**LOUDOUN COUNTY, VA
TECHNICAL REVIEW**

**PROPOSED
CO-LOCATION
by
VERIZON WIRELESS
ON
145' TOWN OF ROUND HILL WATER TANK**

**CMPT 2007-0012
ZMOD 2007-0010
SPEX 2007-0019**

November 2, 2007

Round Hill Water Tank and Compound

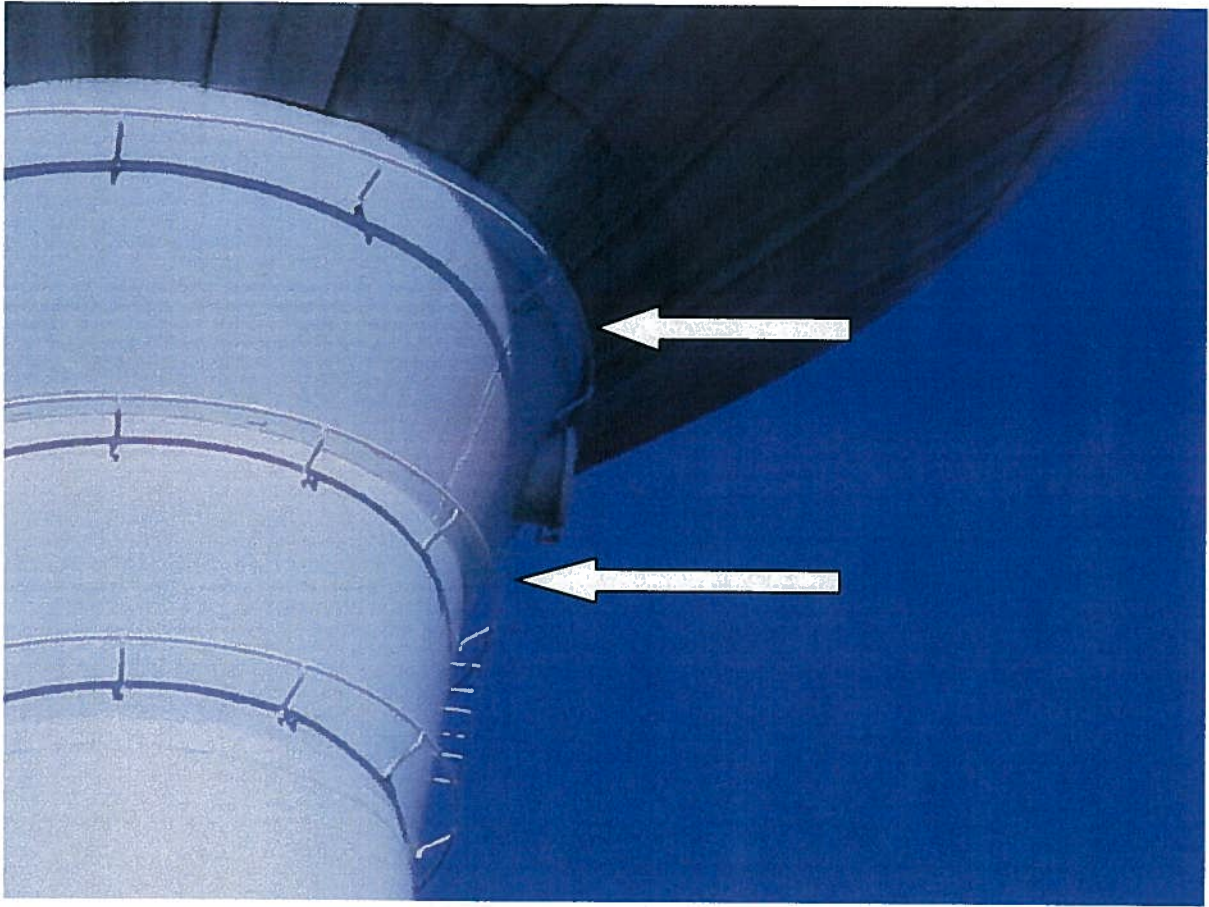
**Proposed Location of Verizon Mask Extension
Approximate AGL of 155'**

Antenna Mounting Rings around “Belly” of the tank.

Blacksburg Water Tank

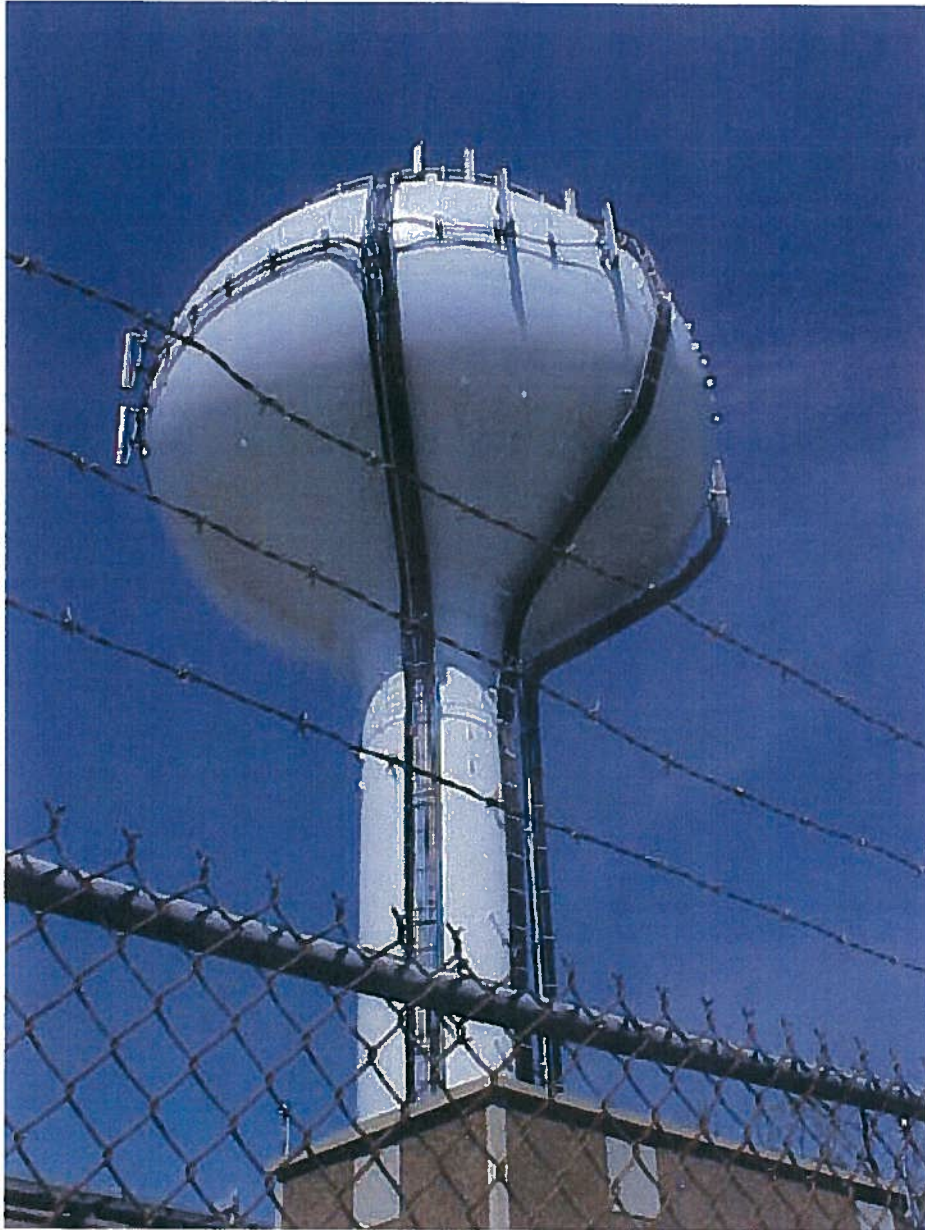
Review the picture titled "Blacksburg Water Tank". This view should be taken into consideration if more than the two co-locators on the top.

Notice multiple 2" cables for co-locators for exterior Mounting.

**Cables can be painted, but becomes a continuing maintenance problem. Notice
Blue paint that chipped off due to freeze/thaw action.**
